Technical Service Bulletin

Squeak or rattle noise in front door area or front sunroof area

50 07 01 Feb. 6, 2007, 2014189/1

Model(s)	Year	VIN Range	Vehicle-Specific Equipment
A6	2007	All	Not Applicable

Figure 1: The front fender. Refer to *ELSA repair manual* for front fender assemble overview.

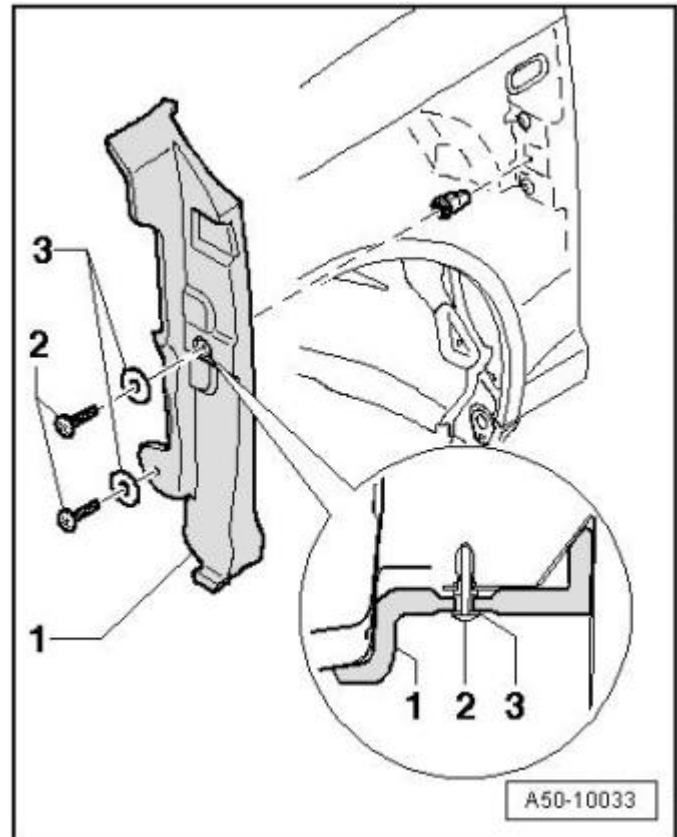
1. Remove front wheel.
2. Remove wheel housing liner.
3. When working on the left side of the vehicle, remove the windshield washer fluid container.
4. Unscrew bolts (Figure 1, Point 2) from expanding clip (Figure 1, Point 3).
5. Remove end plate.

Tip: Tightening torque for bolts (Figure 1, Point 2) is 1.5 Nm.

Figure 2: The end plate. Cloth tape should be installed on the entire surface of side A.

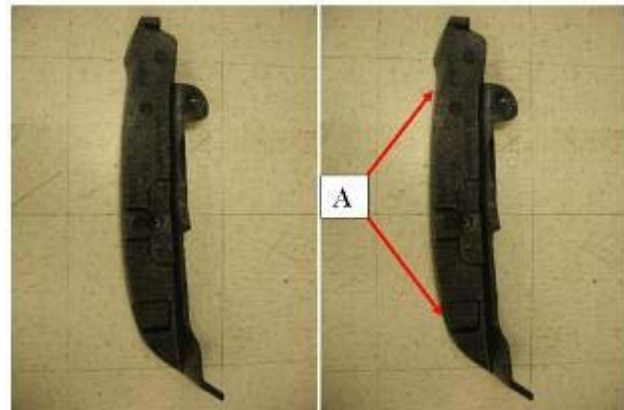
6. Install cloth tape on the entire surface on side A shown in Figure 2.
7. Reinstall the end plate into the fender in reverse order.
8. Test drive vehicle to verify proper repair.
